TECH TALK 0072 MES5MS ENGINE STRANGLER POSSIBLE JAMMING ISSUE 5/2/2007

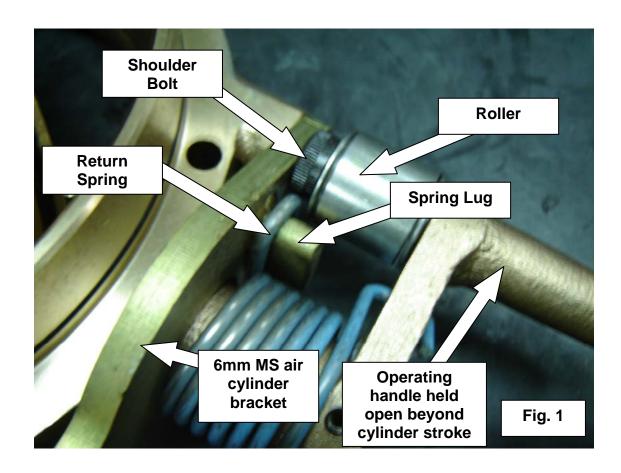
In response to a visit to Sanvik's plant at Tomago by David Kal on 28/3/2007, it is apparent that a small quantity of the MES5MS engine stranglers may jam in the open position if the following two scenarios are met.

- a) The inertia of the air cylinder is enough to force the disk to continue to travel beyond the air cylinder stroke, causing the butterfly disc to open further than 180°.
- b) Several machining / fabrication processes are concurrently carried out to the limit of the allowable tolerances, allowing the shoulder bolt head to contact the return spring, and / or the roller to contact the spring lug on the air cylinder bracket, if the above scenario a) occurs. Refer to Fig1.

- a) Rotate the operating handle by hand in a clockwise direction until the roller and shoulder bolt travel past the spring lug as shown in Fig. 1, noting if the roller contacts the spring lug and / or the shoulder bolt head contacts the return spring. A very light contact is acceptable.
- b) Allow the handle to slowly return to its resting position, noting if the roller contacts the spring lug and / or the shoulder bolt head contacts the return spring. A very light contact is acceptable.
- c) If the contact is heavy, or if the handle jams open, the strangler will require modification. If there is any doubt as to if the contact is light or heavy, it is safest to presume the strangler will require modification.

By replacing the existing shoulder bolt with one 5mm longer and adding a new spacer bush, any chance of jamming is eliminated as the head of the longer bolt acts as a positive stop against the bracket edge. This positive stop restricts the roller from travelling too far beyond the cylinder stroke. This design has been successfully cycle tested by Liquip International and will be implemented on all new MES5MS stranglers.
